# Site Accessibility Evaluation

## Jail and Sheriff's Office

**511 S Capitol St  
Iowa City, IA 52240**

February 3, 2019

### Finding: 1

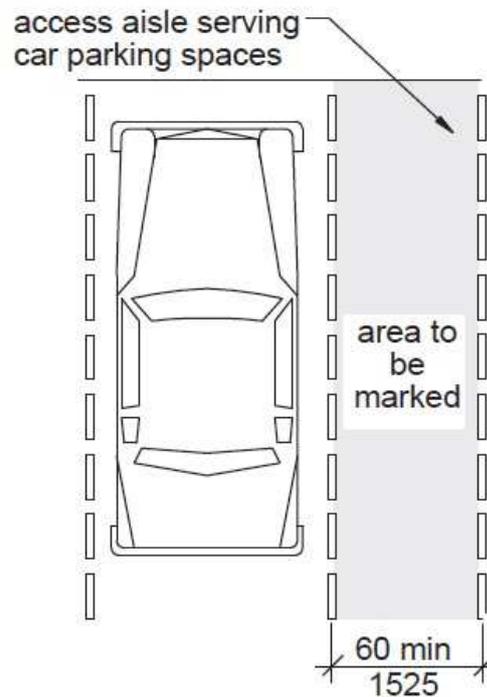
The access aisle is not a minimum 5 feet wide.

access aisle 51"

Repaint access aisles to be 5' each

### Finding: 4

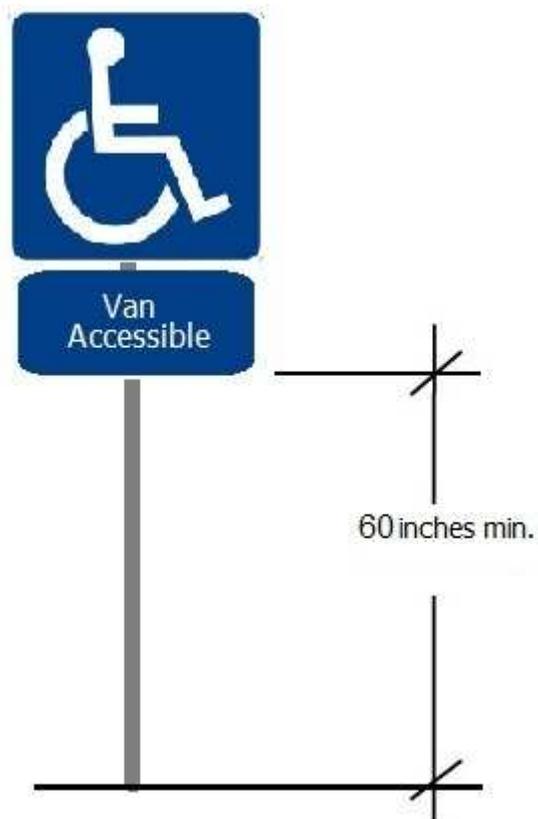
The parking sign is mounted too low.

signage at 54.75" and not R7-8

Raise existing accessible parking signs so lowest end of bottom sign is min 60" aff a R7-8 sign

**Finding: 8**

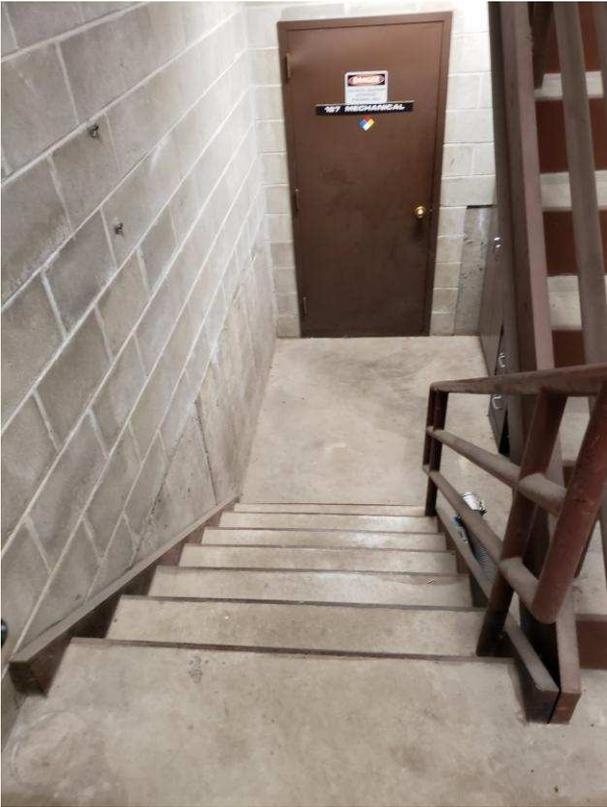
The stairway only has a handrail on one side.

south stair down to  
mechanical 127- one  
side missing

Install handrails on both sides of stairway, mounted 34" to 38" aff with top and bottom extensions and having a 1.25" – 2" in diameter, or a non-circular grip that has a perimeter dimension of 4"- 6.25" max

Finding: 9

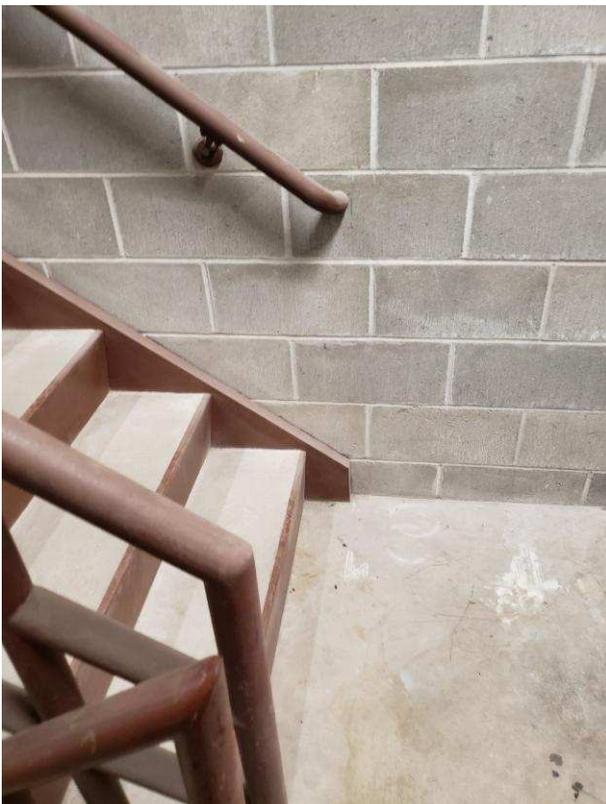
The handrail does not have a compliant extension at the bottom of the stair flight.

south- fails to extend

Install handrails on both sides of stairway, mounted 34" to 38" aff with top and bottom extensions and having a 1.25" – 2" in diameter, or a non-circular grip that has a perimeter dimension of 4"- 6.25" max

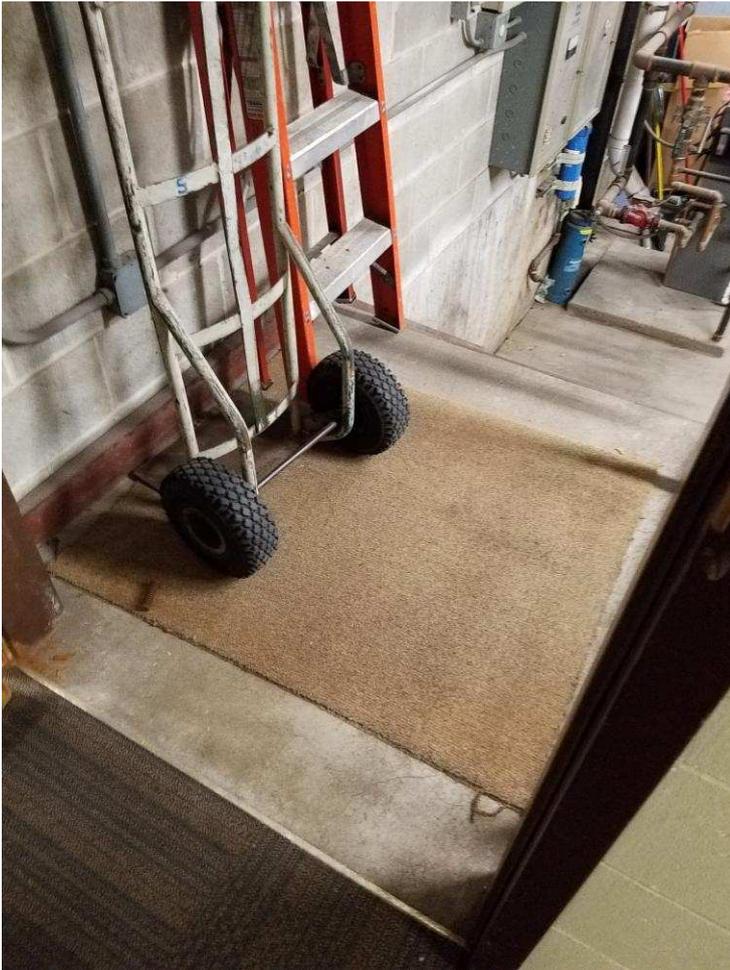
127 - knob, stairs on  
push, fast, 7#

For all doors along the public circulation route, provide required maneuvering clearance on push and pull side of doors; in the alternative, leave as is, correction is technically infeasible

For all doors along the public circulation route, inspect, adjust, and maintain 5 lbf to open interior doors

Replace hardware with lever hardware or hardware operable without a tight pinch or grasp

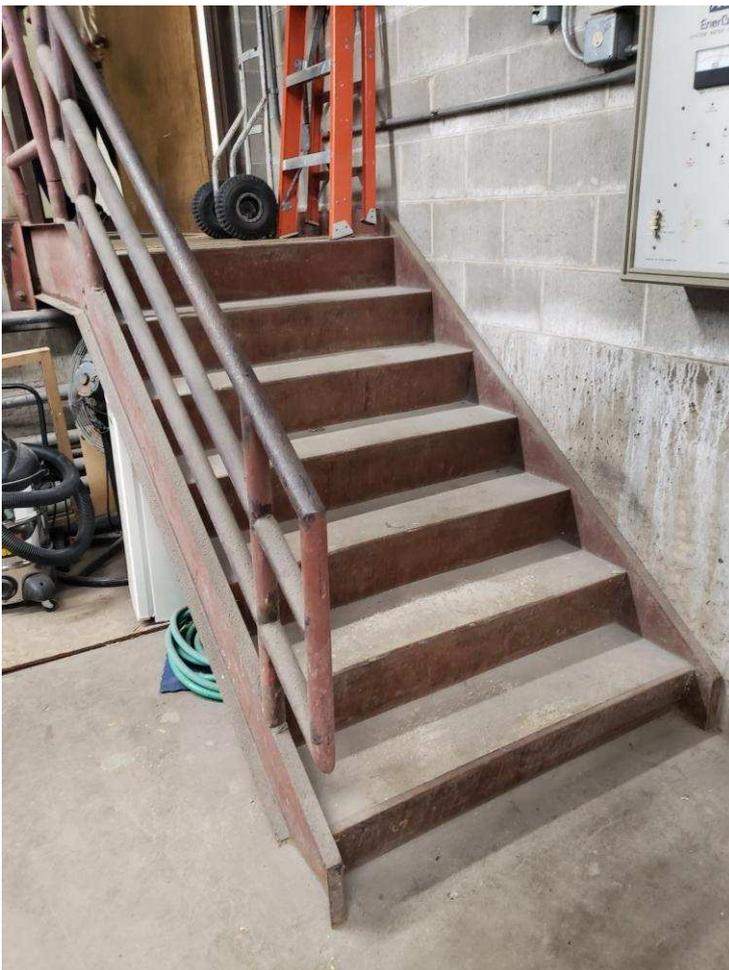
mechanical 127- steps  
only way down into

No AR to lower level employee area, leave as is, and reassign duties if an employee with disabilities requires access here
